Rezoning Transportation Analysis

Petition Number: 2020-178

General Location Identifier: Tax ID 08108503

Date	Description
12-28-20	First Review (WB)

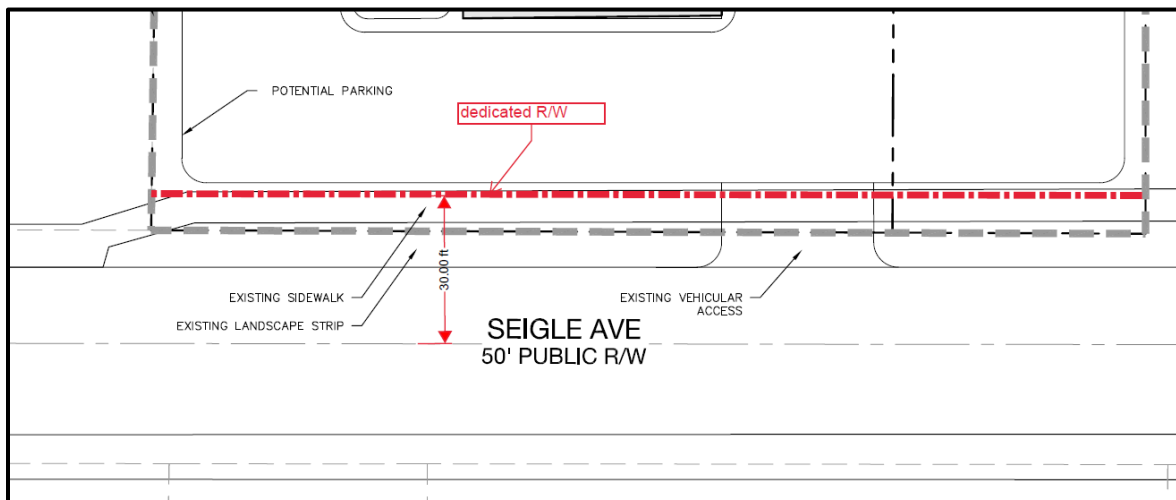
1. **Curbline:** The proposed zoning district has a setback measured from back of the existing or proposed future curbline.
 - a. **Seigle Avenue:** The future location of curb and gutter is in its existing location.

Label and dimension the curb and gutter from the centerline on the site plan.
